Tender for "Expansion of Substation for managing future load demand of the Institute (SITC of 1 X 2000 KVA Transformer, 11KV/415V Substation) "

NIT Number: 147/IISER/PUNE/2019-20

#### MINUTES OF PRE-BID MEETING

### Pre bid Meeting Held at Office of IISER-Pune on 13th January, 2020 at 11.00hrs

SINGLE LINE DIAGRAM NEW PROPOSED

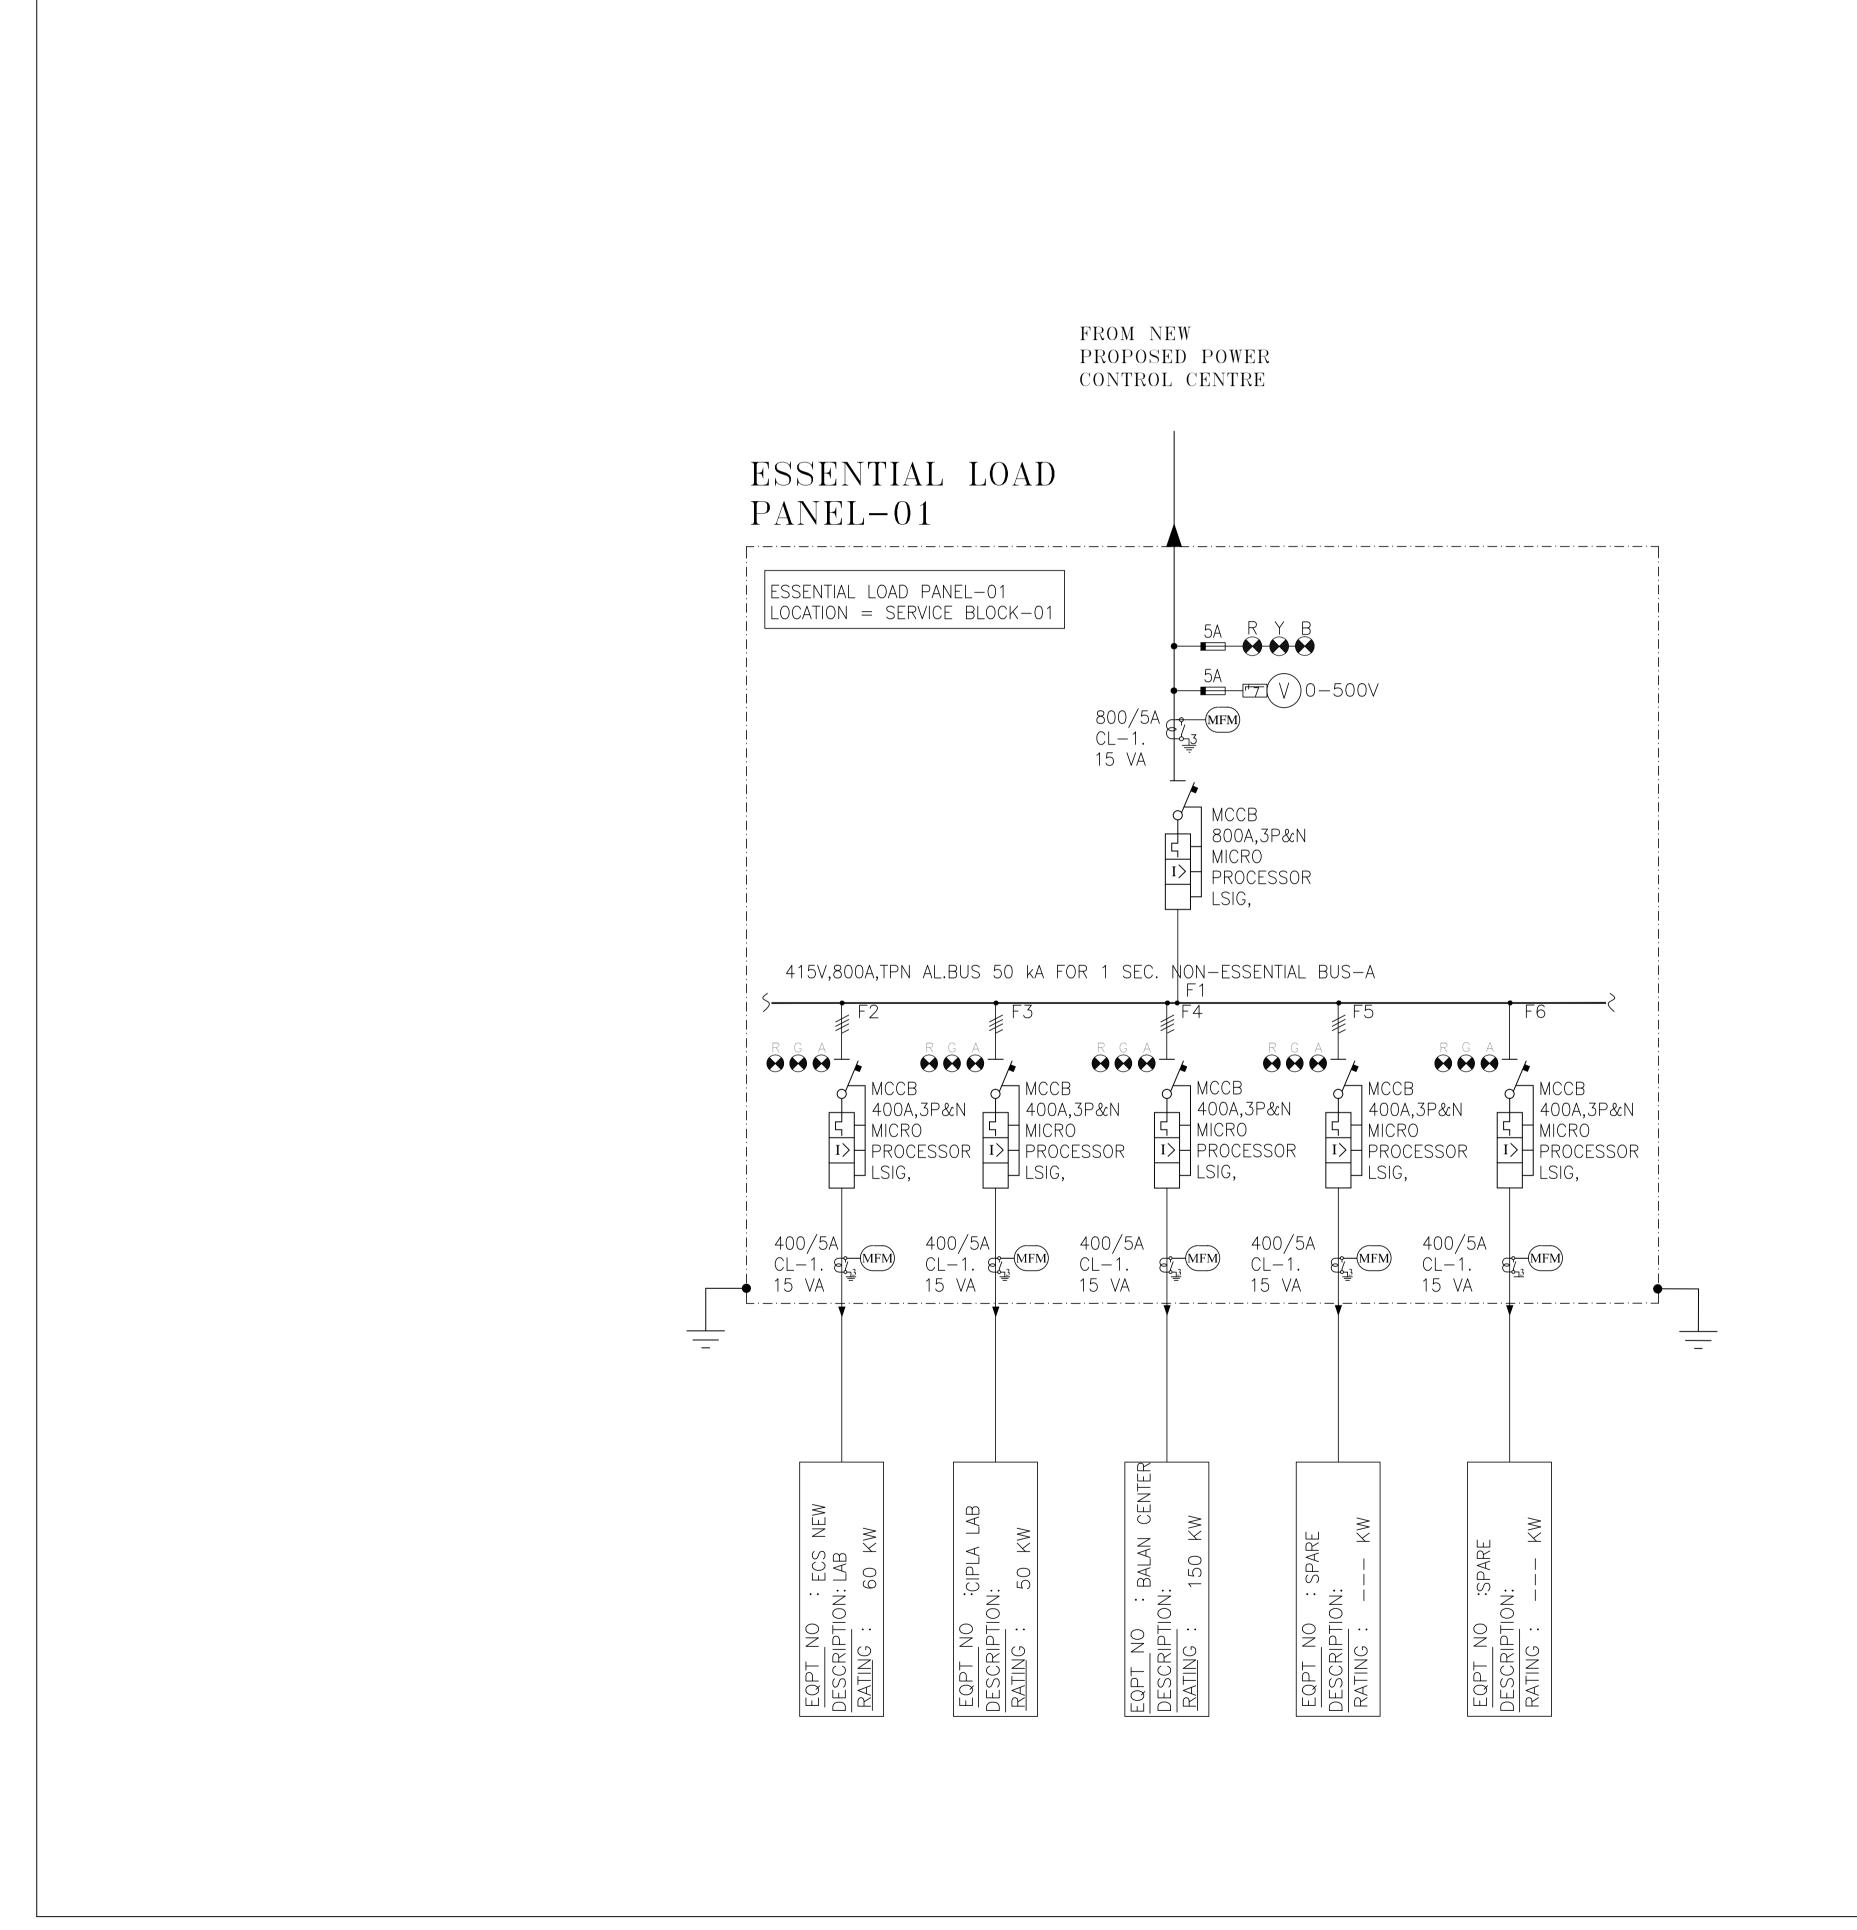
Sr. No.	Ref. to NIT/ BOQ	Point Discussed	IISER Clarification
1	General	EMD and Tender cost exemption	No change in tender clause.
2	BOQ item No 6	HT PANEL:- All protection & specification will be considered for HT Panel as per Tender Single line diagram reference No :- IISER /CRN/EMEA/SLD/EL-02	SLD will be uploaded on https://eprocure.gov.in/eprocure/app and Institute website www.iiserpune.ac.in with Minutes of Prebid meeting
		Single line diagram not attached to the tender document.
